INDEPENDENT REVIEW OF FLOOD MODELLING

Pacific Highway, Woolgoolga to Ballina
upgrade

Final report

JULY 2012

Figure 1: Sub-catchments delineation for the Corindi River floodplain

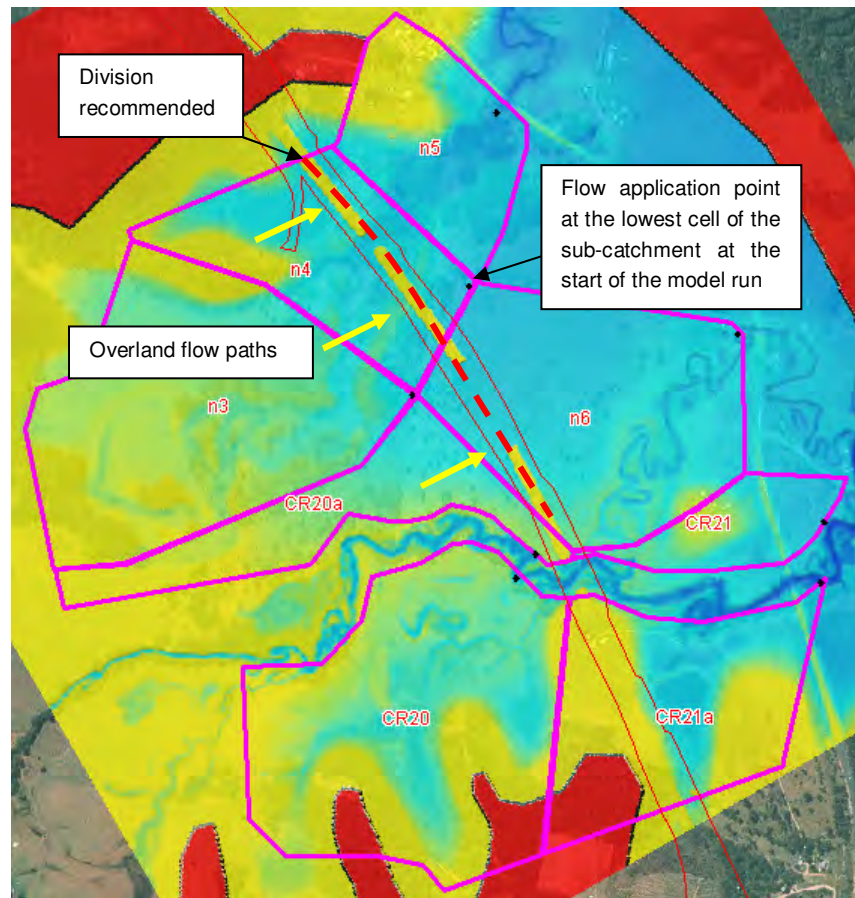
The review of sub-catchment delineation identified locations where flows from catchment areas upstream of a major control have been allocated downstream of the control, in particular for the post-development modelling scenario. One such control is the road embankment that will be constructed as part of the new alignment of the highway located west of the existing Pacific Highway, where upstream flows will be impeded by this control feature before reaching the downstream floodplains. With the current sub-catchment delineation, flow is allocated downstream of the embankment at the start of the simulation run when the model 2D cells were mostly dry, as shown in Figure 1. This outcome is true for the duration of the simulation run as

long as wet cells are absent from upstream of the controls. Consequently, this arrangement may underestimate the extent of flood inundation upstream of the controls though WMAwater have not ascertained to what extent the results may vary.

Figure 3: Impacts above 250 mm upstream of the proposed highway embankment for the 100 year ARI event

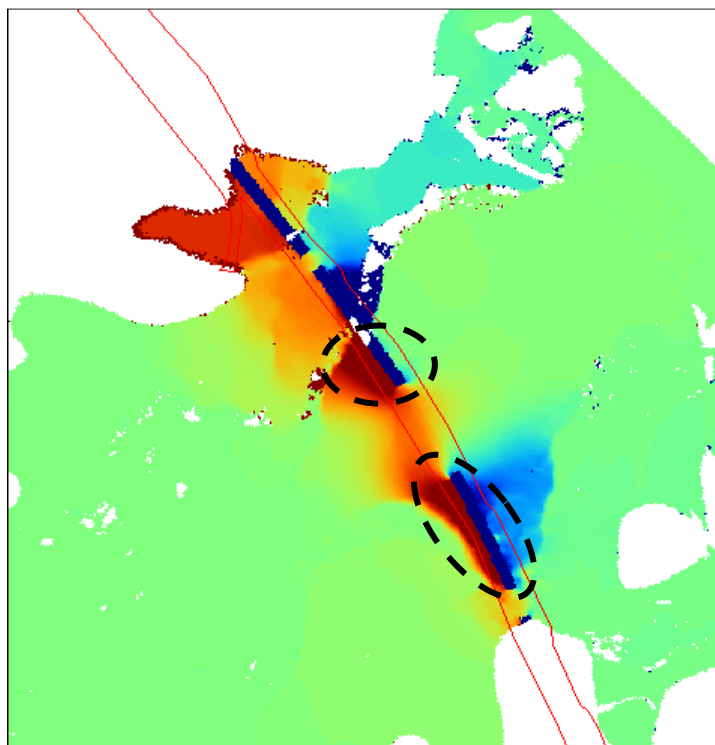
When examining the flood impacts caused by the proposed works within the Corindi River floodplain, afflux above 250 mm was found upstream of the proposed highway embankment based on the 100 year ARI results grids provided to WMAwater, as illustrated in Figure 3. This was reported in Reference 2. It was further remarked that *"To reduce flood impacts on agricultural land to 250 mm, substantially larger bridges would be required. The additional cost of these bridges is considered to outweigh the disbenefits of the impacts."* WMAwater consider this to be a valid argument and recommend that the issue be relayed to the local community and various stakeholders in order to achieve a resolution to the problem.

Figure 6: Omission of proposed works (Chainage 39400 – 40000) from the model

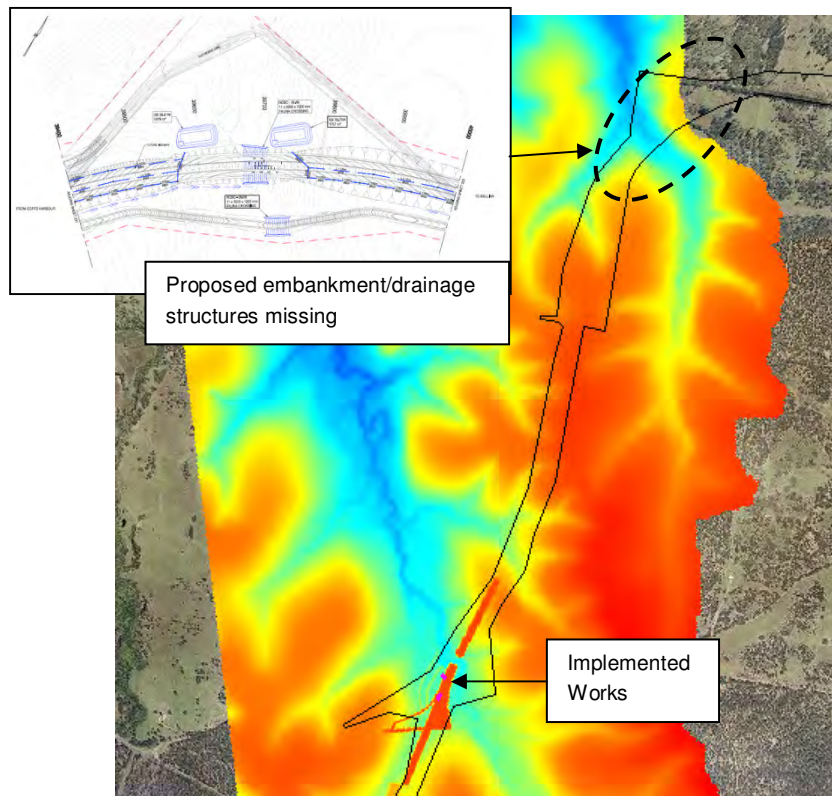
The DEM developed for this catchment was of a finer resolution (based on a 5 m DEM) than the broader DEM developed for the Clarence River model. “Terrain modifiers” have been used to ensure adequate representation of topographic features of gullies/creek in-bank levels as well

as road/embankment/levee crest levels. The raised embankment of the proposed highway upgrade was properly implemented at a level that is above the 100 year ARI peak flood level. However, WMAwater found that the proposed works for the stretch of highway from Ch 39,400 to Ch 40,000 (located on the unnamed creek floodplain north of Pheasant Creek) were omitted or not modelled. The reason for this omission could not be ascertained and WMAwater recommend that the proposed works be included (if not already done so) as part of the flood impact assessment, as the upstream catchments contributing to the afflux caused by construction of the new road embankment may be substantial.

Drainage structures as defined in the RTA concept design plan (Reference 6) for the proposed highway upgrade have largely been implemented in the model with the exception of the proposed works for the stretch of highway from Ch 39,400 to Ch 40,000 (located on the unnamed creek floodplain north of Pheasant Creek) as discussed previously. Further details of included drainage structures in the modelling are provided in Appendix C. Also, the impact of blockages on the performance of these structures was not investigated (the implication of this is

Figure 8: Impacts above 250 mm upstream of the proposed highway embankment for the 100 year ARI event

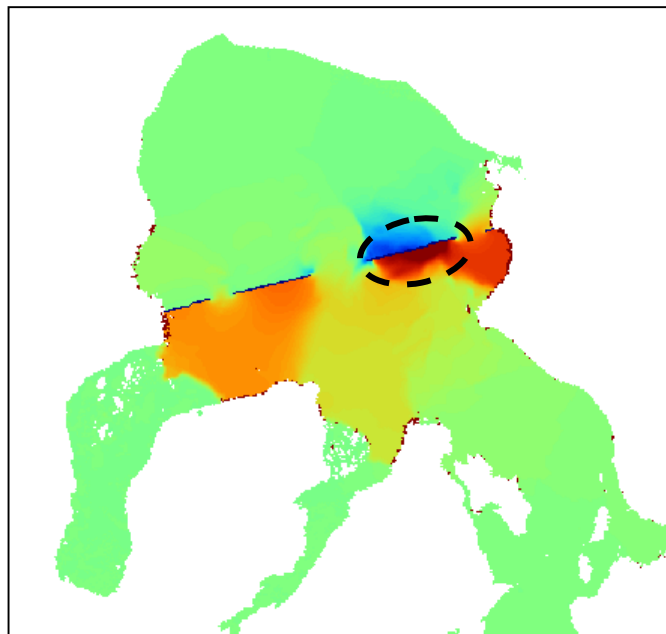
When examining the flood impacts caused by the proposed works within the Coldstream River floodplain, afflux above 250 mm was found upstream of the proposed highway embankment based on the 100 year ARI results grids provided to WMAwater, as illustrated in Figure 8. This was reported in Reference 2. However, there is no mention as to whether it is feasible to extend the proposed bridge span or to introduce additional drainage structures to address the issue. WMAwater recommend that further work be carried out if the impact objectives are indeed not met.

Figure 13: Changes to peak flood level on the floodplain after implementing the corrections

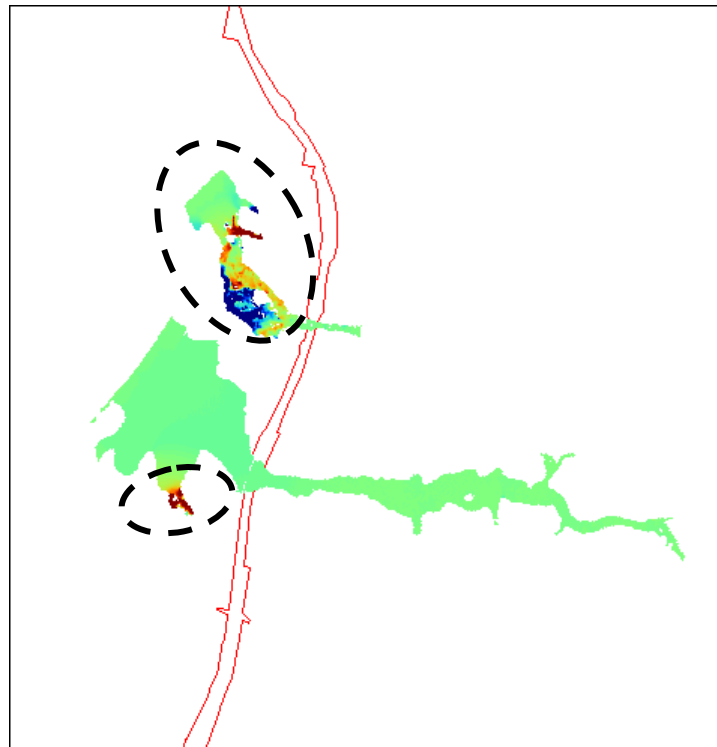
As mentioned previously, WMAwater identified errors in the implementation of TUFLOW's Rainfall (RF) option that enables the application of rainfall hyetographs instead of runoff hydrographs as inflows into the hydraulic model. Firstly, the “RF” option was omitted from the “Read MI SA” command line meaning that the rainfall time series data were read as flow hydrographs instead of rainfall hyetographs as intended. Secondly, the TUFLOW user manual (Reference 7) states that “The rainfall time-series data must be in mm versus hours” and “Initial and continuing losses are entered as attributes to the 2d_sa layer”. WMAwater found that both have not been carried out as the rainfall time-series data were specified in mm/hr versus minutes and losses were not specified in the corresponding 2d_sa layer. In addition, the contributing catchment area has to be specified in km² and a rain gauge factor should be included as one of the additional attributes for the “RF” option. The implication of these errors on the impact assessment results nevertheless is minimal as the affected sub-catchments are mostly located downstream of the proposed embankment and as such any changes to the peak flood level (with the corrections implemented) is confined to the downstream area, as can be seen from Figure 13. Having re-run the model with the corrections in place, WMAwater also observe a more realistic inflow/outflow hydrograph as shown in Figure 14 whereby the downstream sub-catchments modelled using TUFLOW's RF option are contributing to the flow peak earlier on as opposed to the later stages of the modelled flood event.

Figure 17: Abnormalities found in the Zpts check layer

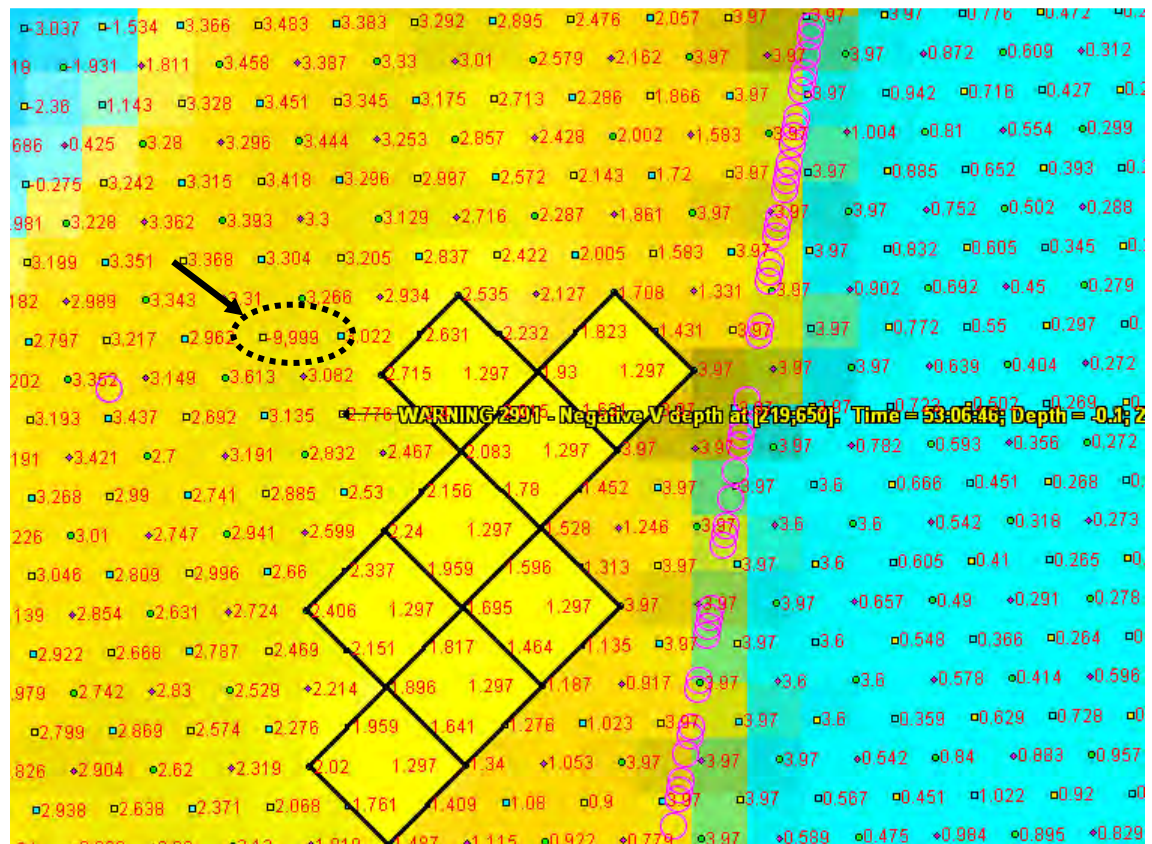
“Terrain modifiers” have been used in this model to ensure adequate representation of topographic features of gullies/creek in-bank levels and levee/road/embankment crest levels. Some were also used to improve on model instabilities, though this is not unreasonable. The raised embankment of the proposed highway upgrade was properly implemented at a level that is above the 20 year ARI peak flood level but allowing overtopping for the 100 year ARI flood event. Examination of the final 2D elevations (known as Zpts in TUFLOW) used by the model, however, revealed a few abnormalities that might be intentionally/unintentionally created which could have caused the instabilities in this model. One example of this is shown in Figure 17 (Zpt = -9,999). Another example is shown in Figure 18 whereby the 2D SX cell that facilitated the transition of flow from the 2D domain into the 1D reach (or vice versa) was lowered excessively

through the use of a “Z” flag. The TUFLOW manual states that “It is not recommended to use the Z flag without first checking that the reason for the discrepancy in elevations between 1D and 2D domains is appropriate.” Thus, a thorough review of the final topography used in the model is warranted.

Figure 19: Inflow boundary condition for the Esk River and extent of hydraulic model boundary

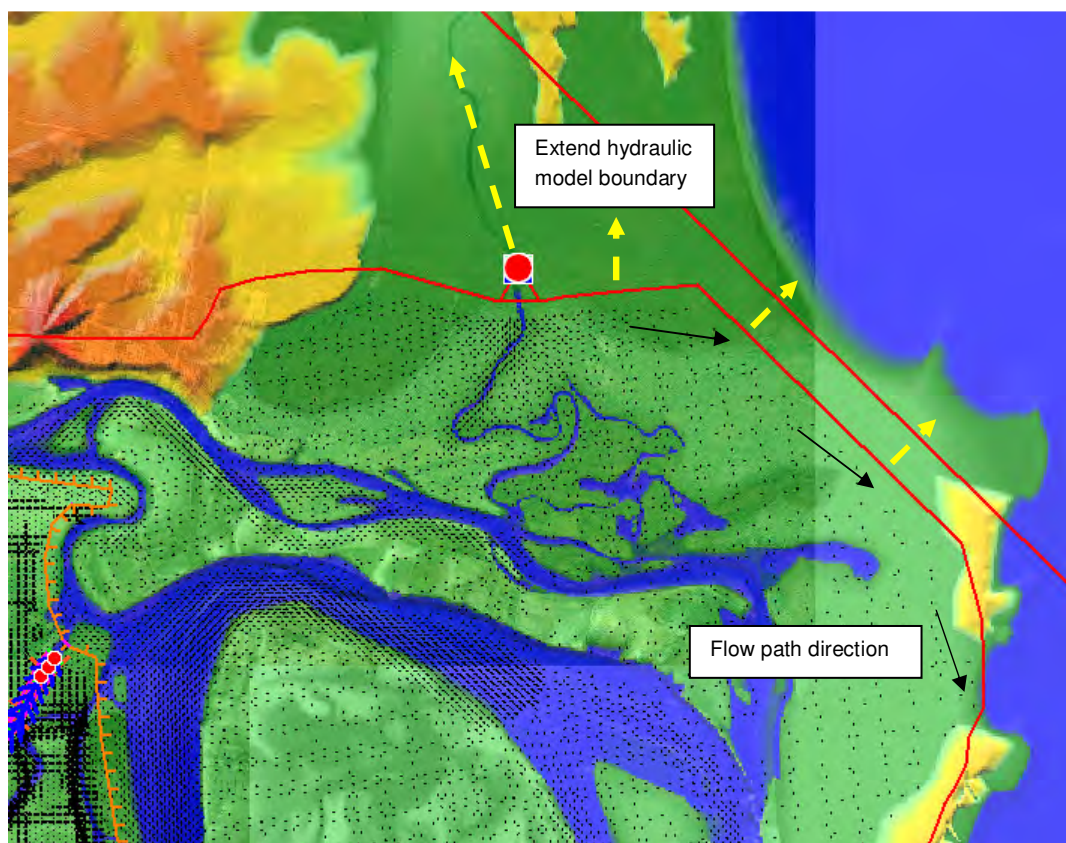
The inflow boundary conditions for the Clarence River and its tributaries have been implemented properly, though the ones for Broadwater Creek and Esk River could be relocated further upstream. The premise of this is that the current boundary where the inflows transition from the 1D node into the 2D domain is located along the existing flow paths within the floodplain and the hydraulic model boundary acted as an “imaginary” wall that prevented water from filling the remaining flood storage available in the floodplain (refer to Figure 19) or retained more water in the model instead of allowing them to discharge freely out of the model. Relocating the boundary further upstream, for example, may result in a slight reduction of the predicted peak flood level, but the implication of this oversight is minor when compared to the total floodplain storage available in this particular model. For the boundary close to the ocean, it is also recommended that the hydraulic model boundary be relocated and placed along the shoreline, as well as implementing a tailwater boundary condition similar to that of the Clarence River ocean outlet.

Figure 20: Missing 2D-2D connection for the refined Shark Ck basin domain

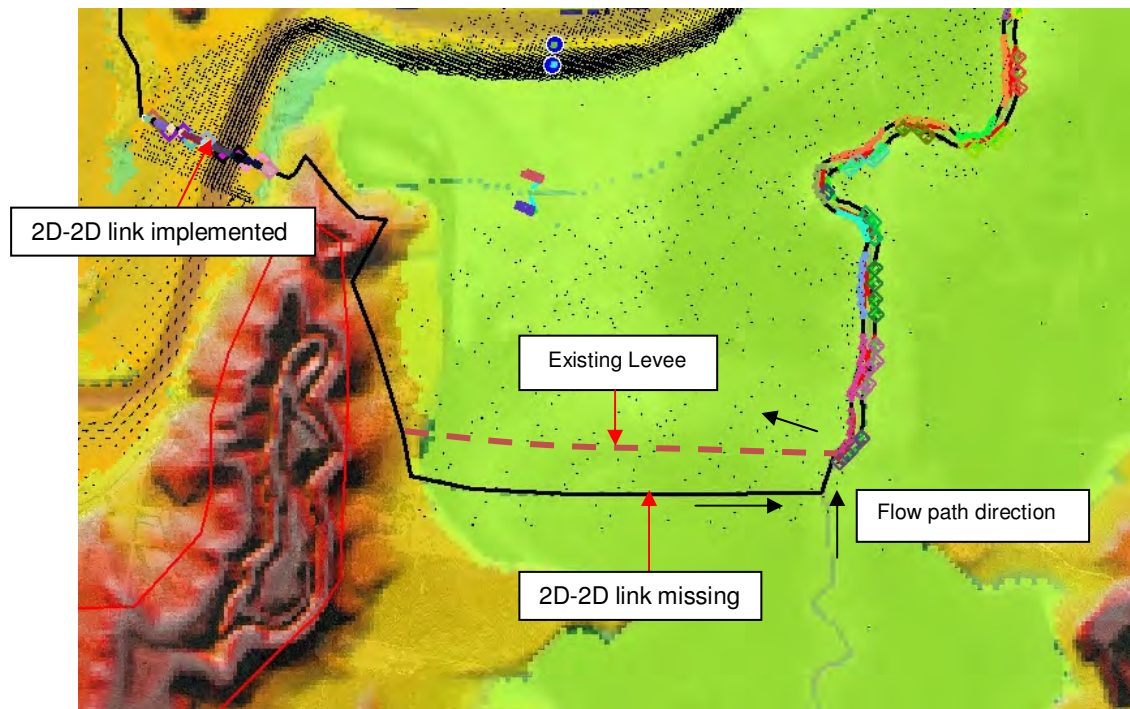
The linking or “stitching” of the multiple 2D domains has been implemented correctly with the exception of the southern boundary of the refined model domain of the Shark Creek basin. It was determined that the 2D-2D link polyline necessary for the transfer of the momentum of flows is missing at this location (refer to Figure 20). Consequently, flows coming down from the upstream catchments were prevented from entering the refined domain by this “imaginary wall” and instead took a detour through Shark Creek to enter into the lower floodplains. Upon closer

examination, there exists a levee close to the boundary with a maximum elevation of 2.06 mAHD, thus the modelled flood behaviour replicates to some extent what is actually taking place in existing conditions. However, the 20 year ARI peak flood level for this location was determined to be around 3.75 mAHD and therefore overtopping of the levee occurs for the larger events and the current setup would not have modelled this phenomenon. Fortunately, the peak flood levels predicted on both sides of the “wall” are the same, even though the flow paths have been altered from their actual behaviour. The implication of this is that the momentum and timing of the flows through this part of the floodplain will be incorrect. This can be fixed by adding the 2D-2D link, preferably located along the existing levee.

Figure 21: Impacts of up to 100 mm at Chatsworth/Harwood Island for the 20 year ARI event

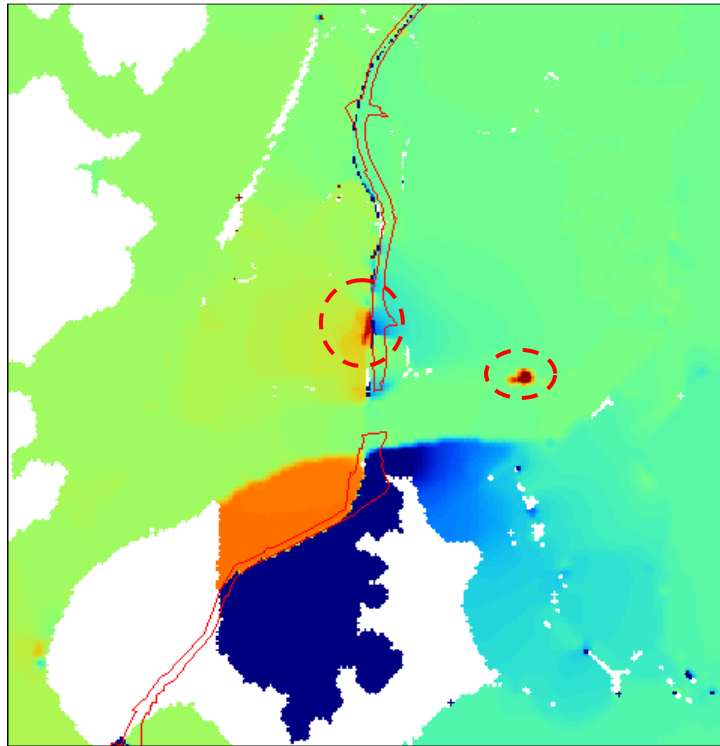
When examining the flood impacts caused by the proposed works within the Clarence River floodplain, afflux of up to 100 mm was found at the Chatsworth/Harwood Island floodplain based on the 20 year ARI results grids provided to WMAwater, as illustrated in Figure 21. This finding does not concur with Figure 3.18 as shown in Reference 2. WMAwater are not able to determine whether the same results were used for reporting but recommend further work be carried out if the impact objectives are indeed not met.

Figure 24: Available flood storage behind hydraulic model boundary

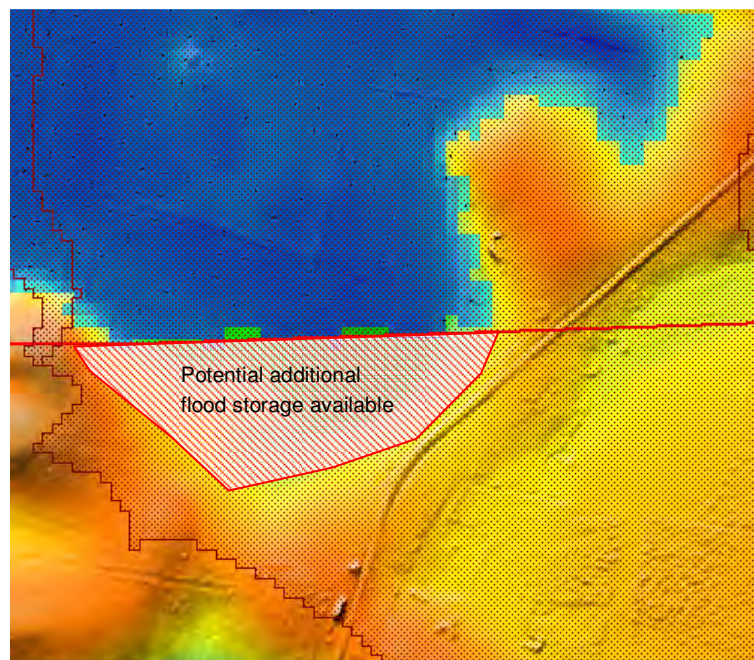
In examining the hydraulic model boundary, it was found that for several locations the boundary acted as an “imaginary” wall that prevented water from filling the remaining flood storage available in the floodplain (refer to Figure 24) or retained more water in the model instead of allowing them discharge freely out of the model. Relocating the boundary to the top of the ridge for example may result in a slight reduction of the predicted peak flood level but the implication of this oversight is minor when compared to the total floodplain storage available in this particular model.

Figure 26: Wrong attribute for 1D bridge/channel

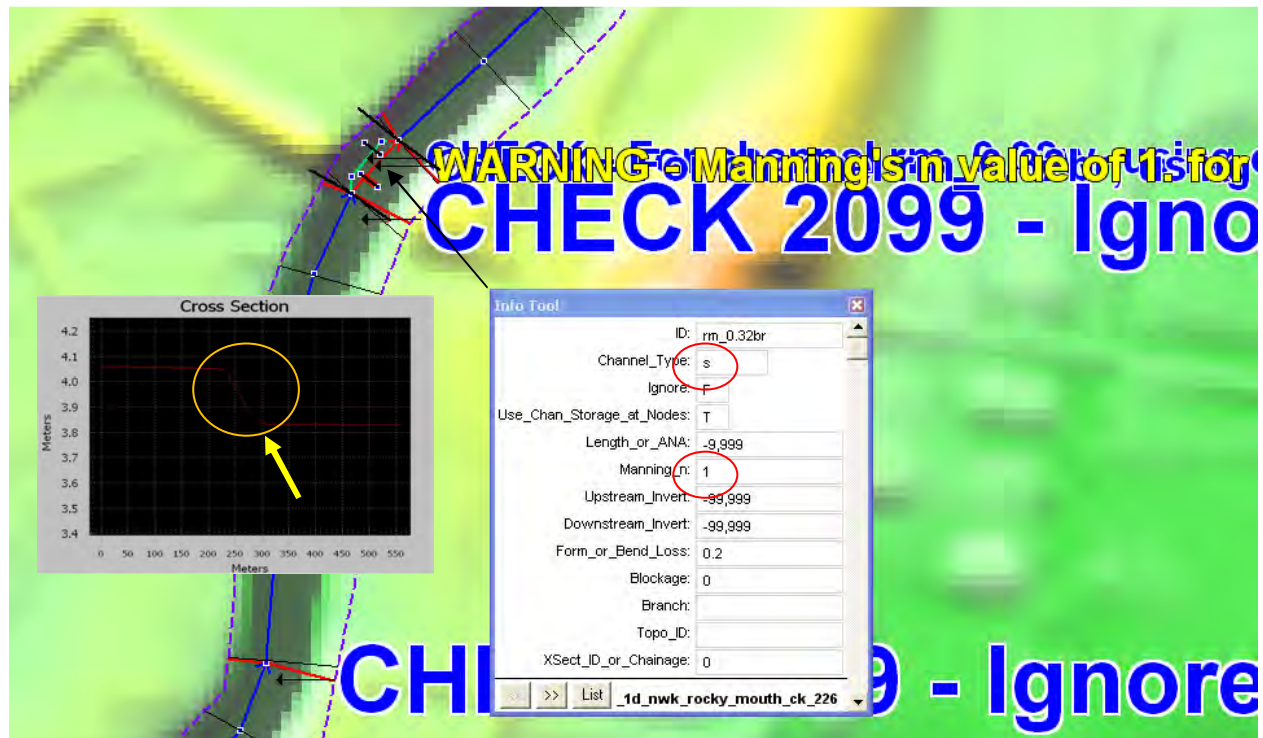
WMAwater also identified specification errors in relation to the attributes for one of the 1D bridge/channel located along Rocky Mouth Ck. The implication of adopting “S” (open channel) for the “Channel_Type” attribute instead of “B” (bridge) for this particular 1D section is that a Manning’s “n” value of 1 was used by TUFLOW that significantly attenuates flows for this section of the open creek, as can be seen in Figure 26. The Manning’s “n” attribute is ignored if the “B” attribute is specified instead.

Figure 27: Flow hydrographs sampled from downstream of the confluence of Broadwater and Richmond River

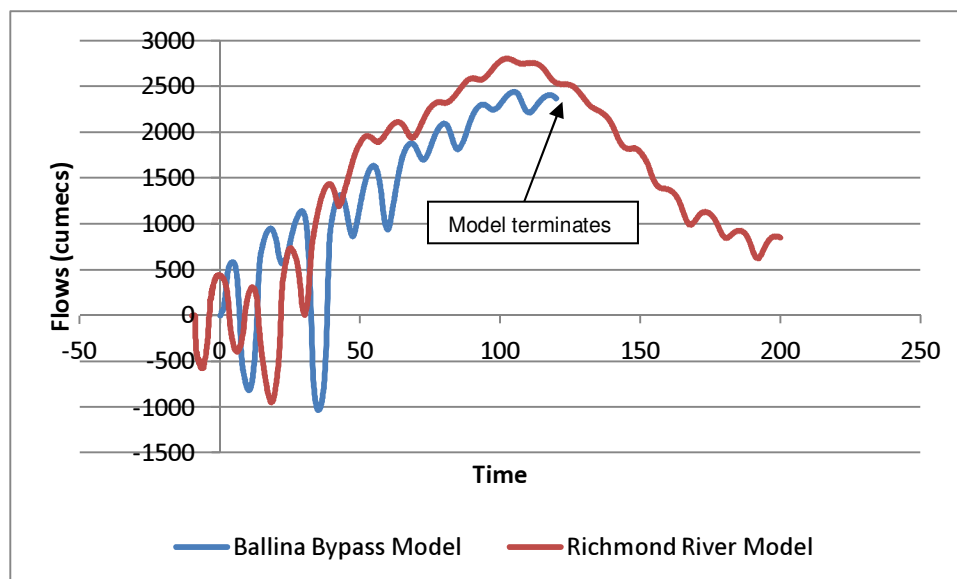
Inspection of the flow hydrograph for the Richmond River (sampled from downstream of the confluence of Broadwater and Richmond River) revealed that the model may have been terminated prematurely soon after the river reaching its peak water level, as shown in Figure 27. WMAwater recommend that the model run time be extended to ensure that the peak of the river is modelled in entirety as it influences the peak flood level predicted for the downstream side of the Pacific Highway.
